SEWAGE DISPOSAL SYSTEM

MARYLAND STATE DEPARTMENT OF HEALTH

SUBDIVISION Buckskin Lake ROAD 4254 Buckskin Lake Dr. LOT 14

PROPERTY OWNER Alex Pagnotta

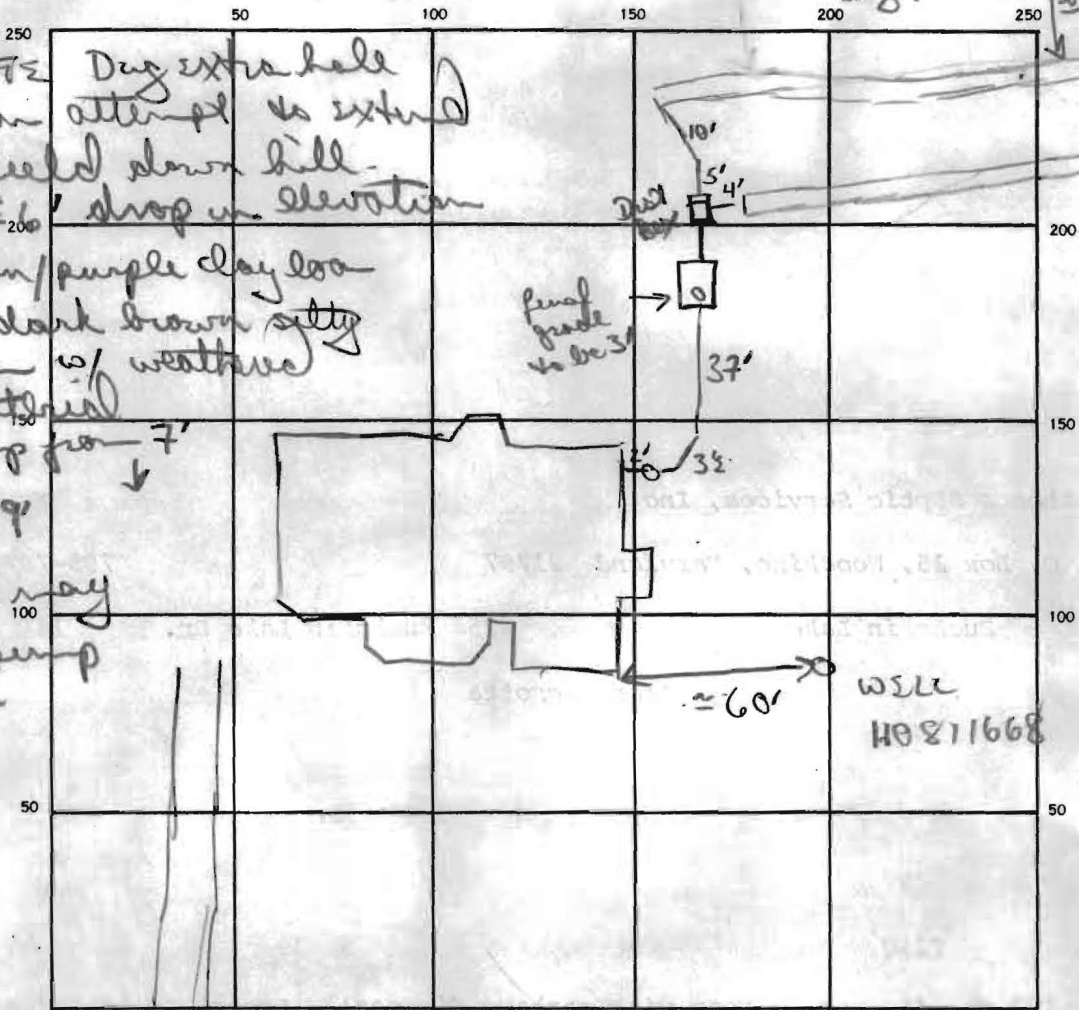
OK TO INSTALL 4 BR SYSTEM
PER OWNERS ATTACHED LETTER 3/26/87
CW

SEPTIC TANK CAPACITY 2000
2250 GALLONS NUMBER OF BEDROOMS 5 4

REMARKS 3/26/87 part of perc field lost due to inaccurate topog + house location. Adjusted inlet on top to get contour OK to cover from house to tank OK to add stone pipe paper to both trenches, OK to continue covering.
